April 28, 1997

## PETITION FOR RULEMAKING REGARDING MOTORCYCLE SIDE AND FRONT REFLECTORS

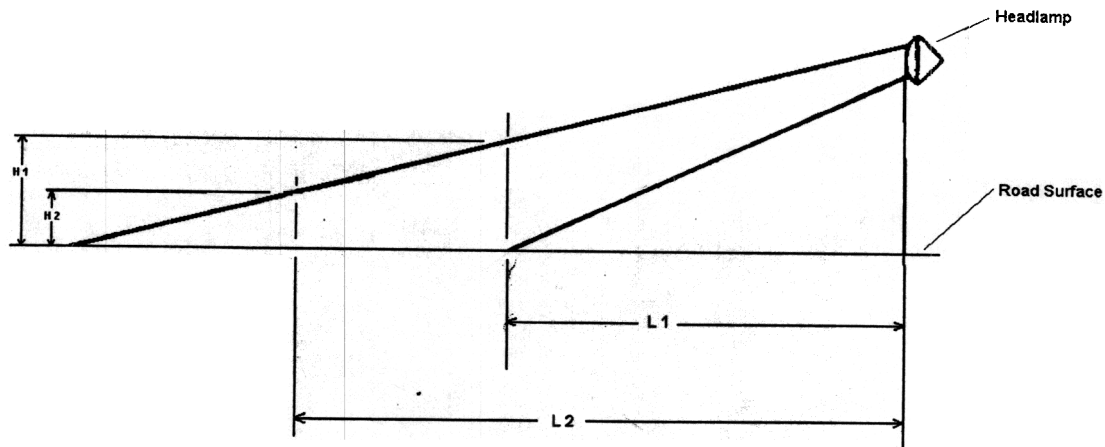
The proposed height reduction will increase safety with respect to approaching vehicle illumination. A lower reflex reflector height will increase the distance between the motorcycle and the approaching vehicle at the point where reflex reflector illumination occurs. See illustration below:

As can be seen, the approaching vehicle observation distance increases from L1 to L2 with a reduction in reflector height from H1 to H2 thus allowing the motorcycle to be recognized when it is farther away from the approaching vehicle resulting in increased safety.
